Technical Information

Service 123/22 ENU

WNH7 - Replace Pressure Sensor for Air- Conditioning System (Workshop Campaign)

| Model Line: | Macan (95B) |

Installation position of pressure sensor

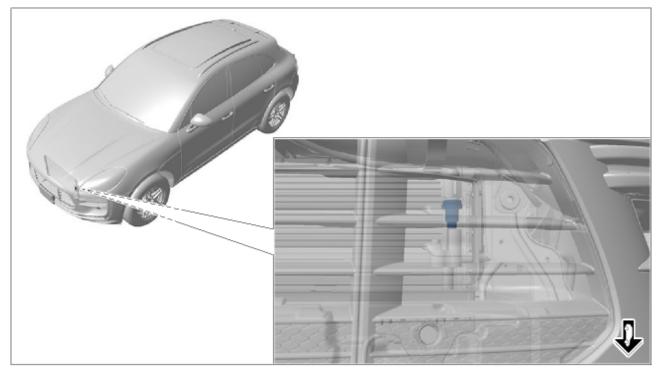
| Model Line: | Macan (95B) |
|------------------|---|
| Information: | A pressure sensor, which does not meet the required specifications, may have been installed on the condenser for the air-conditioning system on the affected vehicles. This can result in restricted function of the air conditioning system. |

- Pressure sensor (replace)

| Model Line: | Macan (95B) |
|------------------|---|
| Action required: | Replace pressure sensor on the condenser. Information Every vehicle is assigned just one campaign scope. To find out which scope is assigned to the vehicle, see PCSS Vehicle Information. |

- 10 **Install new** pressure switch with the part number V04015800AT and **new** O-ring with the part number V04015800CA. *⇒ Workshop Manual '878319 Removing and installing pressure switch'*
